UNITED STATES PATENT AND TRADEMARK OFFICE

APPLICATION NO.	FILING DATE	FIRST NAMED INVENTOR	ATTORNEY DOCKET NO.	CONFIRMATION NO.
10/669,533	09/24/2003	Jeffrey A. Lucas	61605US003	4631

Office Action Summary

DETAILED ACTION

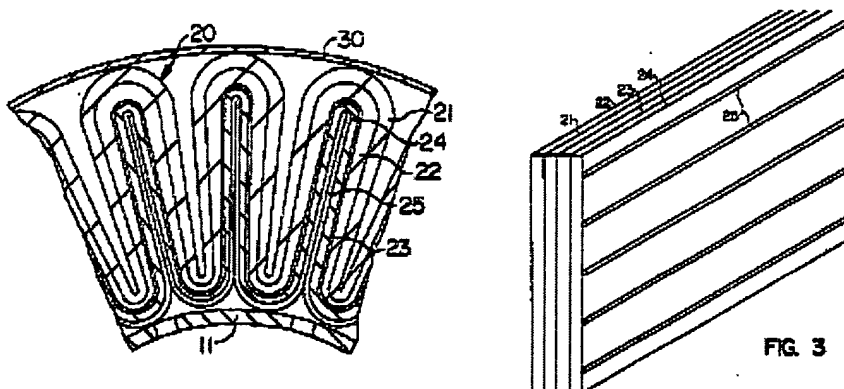
Miller teaches a filter element including a filter media 23, an upstream support 21 and a multi-layer downstream support 22 and 24 (note that the cushioning layer can be between the filter

layer and either of the upstream and downstream supports, see col. 4, lines 17-21). The second downstream support layer 24 includes “ribs” 25 [as in claims 1, 6, 12, 13 and 22]. The cushioning layer (or first downstream support, see col. 8, lines 42-45) is a thin, highly porous, nonwoven, polyester layer made by a wetlaid process (col. 5, lines 29-46) [as in claims 7, 9-10, 14 and 16-17]. The examiner considers such a layer made by the same process and material disclosed by the applicant and having a thickness less than 100 microns yet being highly porous as having its surface contact points “minimized”. As shown in e.g. figures 1 and 6, the filter element includes a perforated core, an outer cage and end caps [as in claims 13 and 20-21]. The filter media is pleated to have longitudinally-extending, radial pleats [as in claims 2-3].

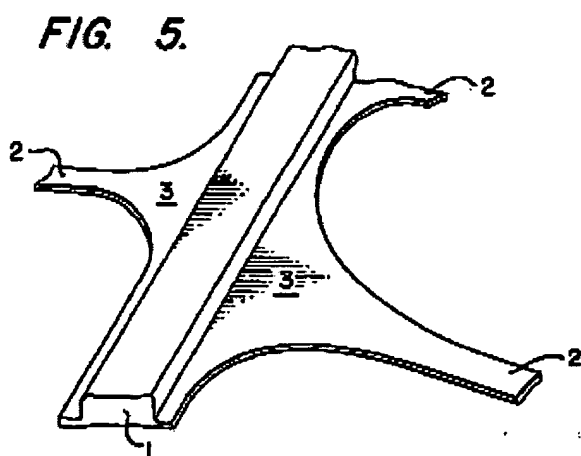
Although Miller teaches his second downstream support can be *any* woven or nonwoven material (col. 4, lines 39-40) and cites an extruded, apertured, polymeric, mesh having “ribs” 25 as an example, he doesn’t mention the layer being an extruded apertured film. However, such is taught by Rasmussen (U.S. 3,954,933). As shown in figure 5 below and also figures 2-3,

Rasmussen teaches a layer comprising an extruded, apertured, polymeric film having ribs 1 and portions 2, 3 between apertures [as in claims 1, 11, 13, and 22]. It is considered that it would have been obvious to one ordinarily skilled in the art at the time of the invention to have at least the

in filters (col. 1, lines 8-13). The direction of the rib shown in figure 5 of Rasmussen is taken by the examiner to be the “machine direction”.
